## DEFENSE NUCLEAR FACILITIES SAFETY BOARD

## Staff Issue Report

**SUBJECT:** Review of Plutonium Stabilization and Packaging System

This memorandum documents an issue associated with the Plutonium Stabilization and Packaging System (PuSPS). This issue was reviewed by members of the staff of the Defense Nuclear Facilities Safety Board (Board) D. Grover and M. Sautman on June 16–17, 1999, at the Rocky Flats Environmental Technology Site (RFETS).

Figure 1. DOE-STD-3013 Inner Container and Glovebox Port Configuration

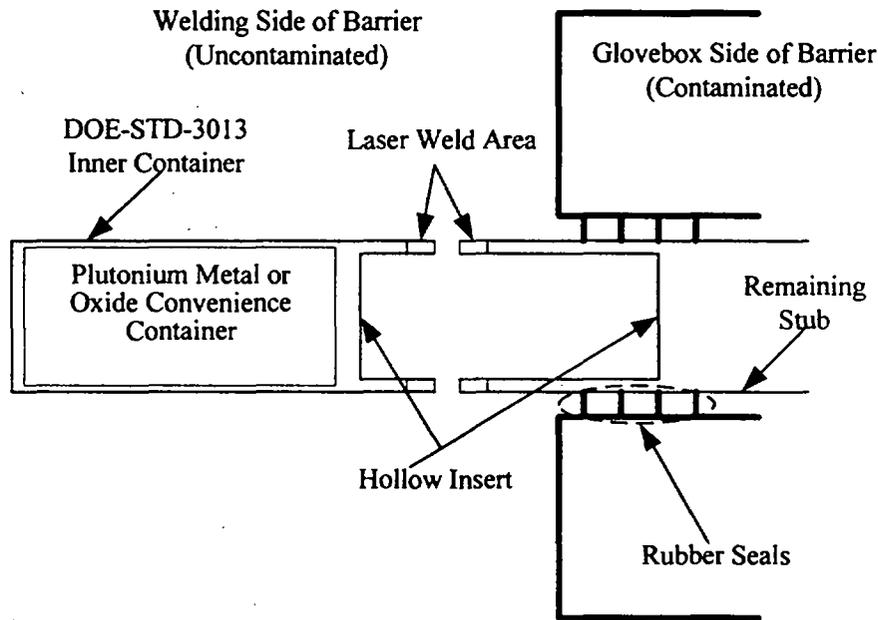
**Contamination on Inner Container.** Per DOE-STD-3013, *Criteria for Preparing and Packaging Plutonium Metals and Oxides for Long-Term Storage*, the outer surface of the inner container of a plutonium package is required to be free of removable surface contamination in excess of the limits specified in 10 CFR 835. In the RFETS PuSPS, the inner can is partially inserted into the side of the glovebox through a series of rubber rings that forms a contamination seal around the can. Plutonium metal or oxide is then inserted into the can, followed by a hollow insert that forms an interference fit in the opening of the inner container. A laser is then used to weld the inner can to the hollow insert. Finally, a laser cuts through the can and hollow insert in the welded area. One side of the hollow insert forms the lid of the now sealed, contamination-free container; the other side remains attached to the upper remnant of the inner can, forming a plug that seals the glovebox port (see Figure 1). RFETS has identified the potential for plutonium oxide present between the container and hollow insert to become trapped in the weld and subsequently vaporized during the laser cutting operation. This material could deposit on the container and result in transferable radiological contamination exceeding that allowed by the storage standard.

The staff considers the planned process improvements appropriate to minimize the probability of contaminating an inner container. However, the PuSPS does not have a method for checking the inner container for contamination to determine whether the container meets the storage standard or identify the extent of any contamination. The PuSPS also lacks the capability to remove any contamination. Additional design changes to incorporate the ability to check inner containers routinely for contamination would be appropriate, allowing verification that the requirements of the standard are being met. In addition, an adjacent work area for removal of contamination above the limits of the standard would be useful to minimize the number of containers not meeting the requirements of the standard.

To deal with this deficiency, RFETS has initiated procedural and design changes to minimize the extent of the contamination on the containers. Daily housekeeping of the gloveboxes will be performed to minimize the quantity of oxide available to contaminate the container. In addition, a fume hood will be added next to the welding and cutting area to draw contamination away from the outer surface of the inner container during cutting. Finally, a confinement barrier will be placed around the weld equipment housing to prevent contamination from being released into the general work area. However, these proposed changes may not prevent the accumulation and migration of contamination along the process path, with eventual release outside of the planned confinement area. RFETS has also initiated an effort to revise the plutonium storage standard to remove the requirement for a contamination-free inner container,

thus eliminating the need to decontaminate or repackage any inner containers that might become contaminated despite the design modifications.
